BELLEFONTE COMBINED LICENSE APPLICATION – RESPONSE TO REQUEST FOR  
ADDITIONAL INFORMATION – BASIC GEOLOGIC AND SEISMIC INFORMATION

Reference: Letter from Joseph Sebrosky (NRC) to Andrea L. Sterdis (TVA), Request for  
Additional Information Letter No. 123 Related to SRP Section 02.05.01 for the  
Bellefonte Units 3 and 4 Combined License Application, dated September 4, 2008

Enclosure  
TVA letter dated October 3, 2008  
RAI Response

Subject: Basic geologic and seismic information in the Final Safety Analysis Report

BLN COL 2.5-1 **Soil Weathering Features in Pleistocene Terrace Deposits near Gadsden, Alabama** **FIGURE 2.5-209**

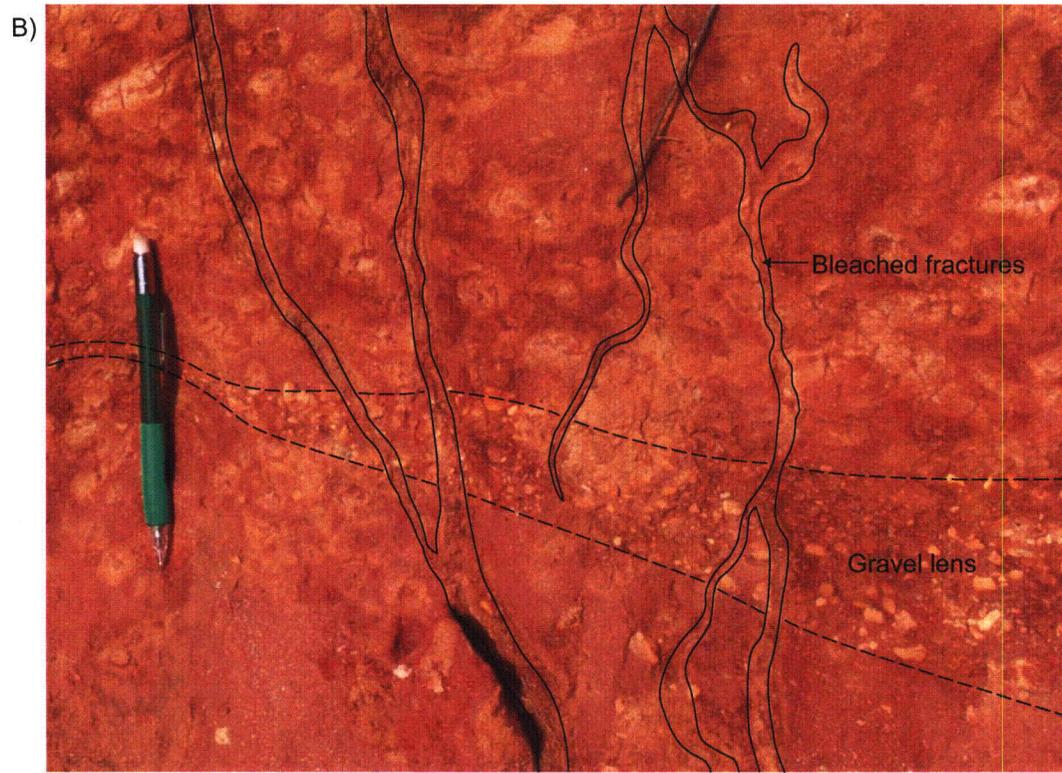
FSAR 2.5.1.1.3.2 describes sub-vertical, upward-widening features in a soil exposure and states that they “resemble non-tectonic soil weathering features (cutans) ....” Please present observations, measurements, or analyses, and figures, photographs, or other illustrations that demonstrate whether or not these features could be seismically induced.

The sub-vertical features are found in the iron-rich horizons of the western and central cut faces, in either the mottled or unmottled horizons. The features appear as sub-vertical veins 0.5 to 2 in. wide, lighter in color than the surrounding soil matrix (FSAR Figure 2.5-209 panels a and b). They are similar to the light colored mottles within the iron-cemented horizon. The veins are seen to occasionally branch upward or downward, and may be part of a group of parallel veins. Vein width is fairly constant with depth, though examples can be found that pinch out with depth or widen near the surface. Some end abruptly at a bedding contact. The edges of the veins are typically lined with reddish iron cementation.

The veins pass through stratigraphic contacts without offsetting or disturbing them. FSAR Figure 2.5-209 Panel A shows several veins passing through a gravel lens bounded by mottled silty clay loam. The gravel is not displaced, and gravel clasts occur within the vein where it passes through the lens.

A new Figure 2.5-209, Soil Weathering Features in Pleistocene Terrace Deposits, Gadsden, Alabama, is added (Attachment 2.5.1-01A).

At an exposure of these high terrace deposits in Gadsden (Field Stop KH9, Figure 2.5-208a) distinct subvertical veins, 0.5 to 2 inches wide, of light brownish gray material, were observed within the yellowish red soil of these old deposits (Figure 2.5-209 panel a). The veins could be traced through a strongly mottled horizon (typically 3 to 5 feet below the surface), through the underlying unmottled partially iron-cemented sediments, to the base of the exposure 6 to 8 feet below the surface. The veins become less distinct in the upper part of the mottled horizon and could not be traced into the upper 0.6 m (2 ft.) of the soil. The veins are seen to occasionally branch upward or downward, and may be part of a group of parallel veins. Vein width is fairly constant with depth, though examples can be found that pinch out with depth or widen near the surface. The edges of the veins are typically lined with reddish iron cementation.

The veins pass through stratigraphic contacts without offsetting or disturbing them. Figure 2.5-209 panel b shows several veins passing through a gravel lens bounded by mottled silty clay loam. The gravel is not displaced, and gravel clasts occur within the vein where it passes through the lens.

Renumbered FSAR Figure 2.5-208a and 2.5-208b

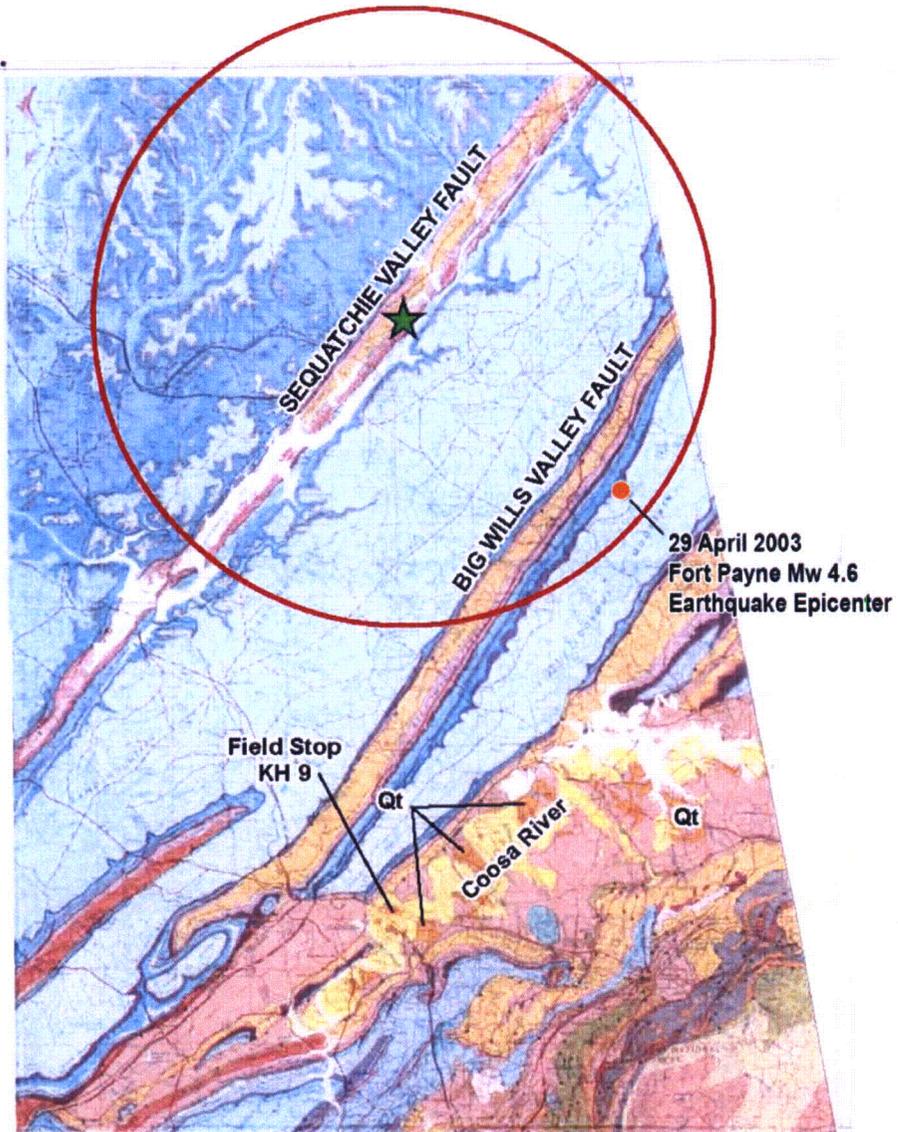
1. COLA Part 2, FSAR Chapter 2 figures are modified by replacing Figures 2.5-208 and -209 as follows:  
Existing Figure 2.5-208, 25-Mi. Radius Geologic Map, will be renumbered as Figure 2.5-208a (Attachment 2.5.1-01B)  
Existing Figure 2.5-209, Explanation of Geologic Map Units and Symbols 25-Mi., will be renumbered as Figure 2.5-208b (Attachment 2.5.1-01B)

In northern Alabama, extensive alluvial terrace deposits are mapped in the Coosa River Valley in the Gadsden to Weiss Reservoir area (Etowah and Cherokee Counties) (Reference 224) (Figure 2.5-208a). The alluvial and terrace deposits are preserved within a broad valley underlain by the Cambrian Conasauga Formation. Structural cross-sections and maps indicate that the Cambrian unit beneath the valley is a near horizontal thrust sheet, referred to as the Rome thrust (Reference 225) (see discussion in Subsection 2.5.1.1.4.2). The meandering river morphology is prominent where the widest part of the Rome thrust sheet is preserved. Downstream of the confluence of Big Canoe Creek and the Coosa River (about 10-mi. southwest of Gadsden), the valley narrows and the Coosa River takes a sharp bend to the south and cuts across the regional structural grain. Quaternary deposits are not shown on the State Geologic Map of Alabama (Reference 225) (Figures 2.5-208a and 2.5-208b) downstream...

**FIGURE 1**  
 Location Uncertainty of Seismicity

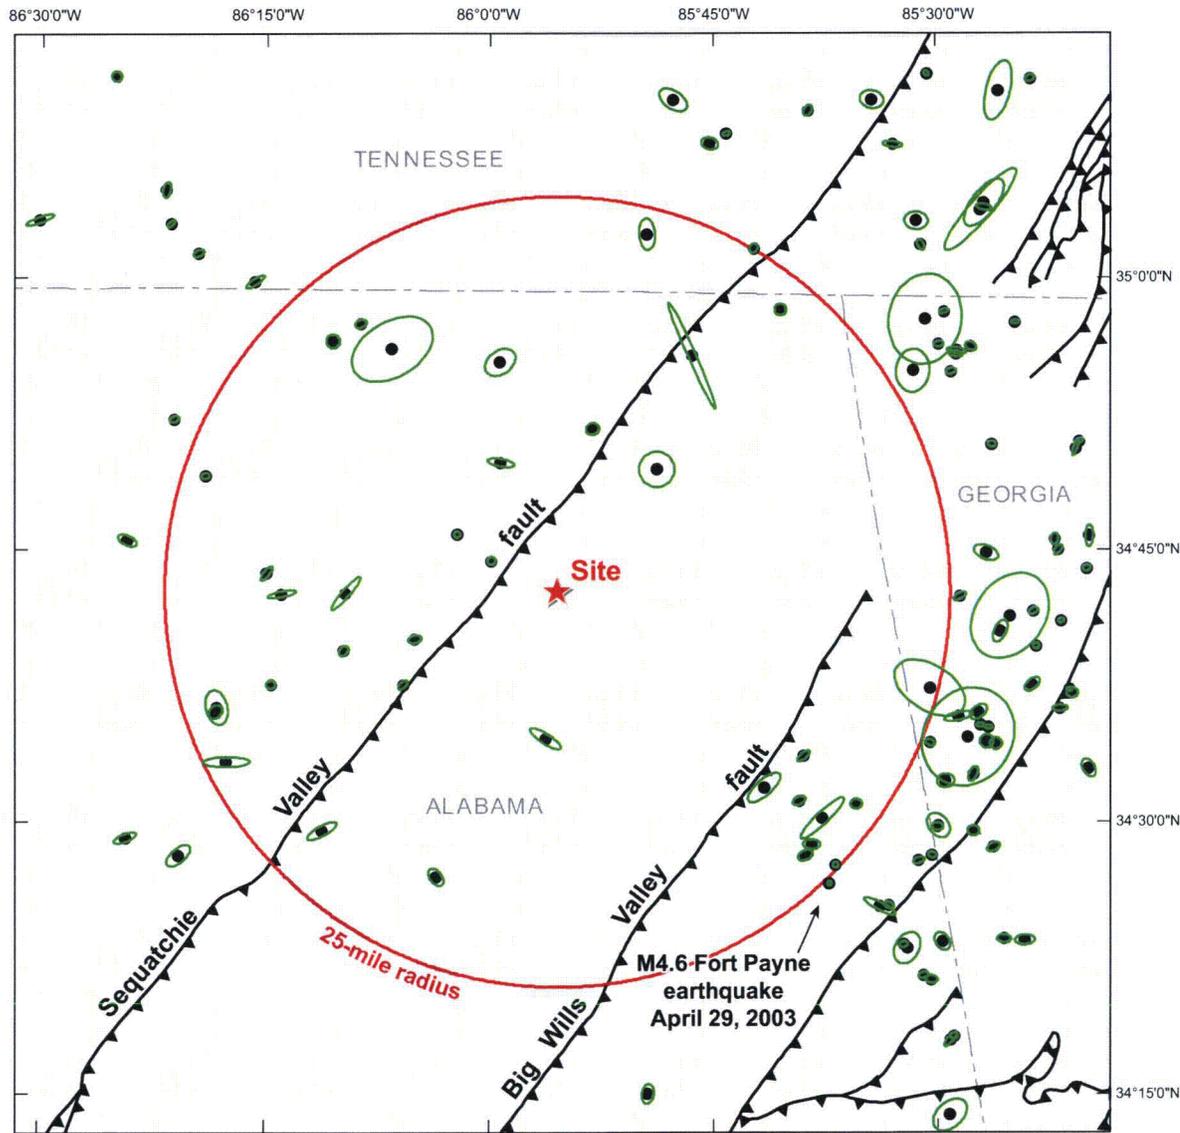
Given the uncertainty in locating earthquakes in most network data, especially at distances corresponding to the Eastern Tennessee Seismic Network stations, distance to the nearest station, station density, crustal velocity structure and etc., please discuss the likelihood that some of the earthquakes are located on one or more of the mapped faults shown in FSAR Figures 2.5-294 and 2.5-220.

Figure 1 (Attachment 02.05.01-03A) shows the projections of the 68% hypocenter error ellipsoids in the horizontal plane for instrumentally located earthquakes in the site vicinity. The data are taken from the Southeastern United States Seismic Network Bulletins, 1973-2006 (Reference 3). Most earthquakes within 25 km of the site are located to the northwest of the surface trace of the Sequatchie Valley thrust, of Late Paleozoic age, which dips to the southeast. Figure 1 shows that the epicenter semi-major error ellipse axes (68% confidence) are on the order of 2 km or less for most of these events, suggesting that they are determined with sufficient accuracy to support the interpretation that the majority occurred to the northwest of the Sequatchie Valley fault and therefore, have no relation to that feature.

Earthquakes with computed epicenters to the southeast of the Sequatchie Valley fault trace could be, in principle, associated with that southeast-dipping Paleozoic fault, or other faults to the southeast shown in FSAR Figure 2.5-294. The critical issue in evaluating any potential association between these earthquakes and faults is the focal depth of the earthquakes. Figure 2 (Attachment 02.05.01-03A) shows a histogram of a focal depths for the 19 events shown in Figure 1 that have a 68% confidence vertical error ellipsoid projection of 5 km or less, and were recorded by at least one station within 20 km of the epicenter. These events represent the best-constrained hypocenter locations, and should have minimum bias in the focal depth estimates due to uncertainty in assumed velocity model. Therefore these events are the most appropriate subset to use in judging the depth distribution of earthquakes.

**FIGURE 1**  
 Location of Wells (red dots) and Seismic Reflection Profiles (wide gray lines), Used to Constrain the Structure of the Appalachian Thrust Belt. Thomas and Bayona (2005) Combine These Data with Geologic Mapping to Create 18 Structural Cross Sections (Numbered Green Lines)

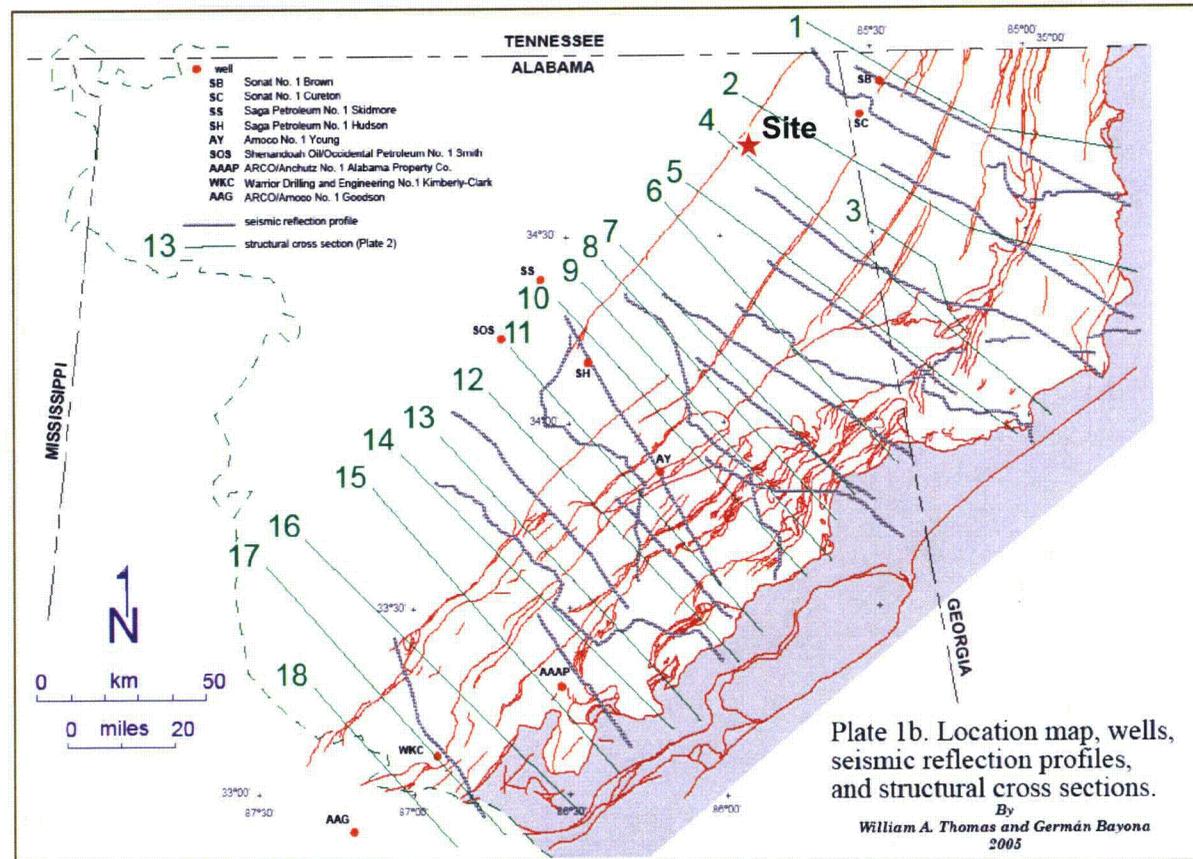
Please provide evidence that all of the thrust faults shown in FSAR Figure 2.5-294 near the Bellefonte COL site sole out into the Appalachian detachment. Figure 2.5-220 shows subbasement faults with the same general northeast-strike and similar locations as those of Fig. 2.5-294. Given fault location uncertainty, explain whether or not some of the faults shown on these two figures could be the same fault penetrating through the detachment.

The seismic reflection and well data used in these studies were generally collected by the petroleum industry. Eighteen parallel seismic reflection profiles, each approximately 50 miles long, cross the thrust belt and four deep wells penetrate the basement (Figure 1 of Attachment 02.05.01-04A). Geologic mapping of the Paleozoic rocks was conducted by a variety of researchers including the authors.
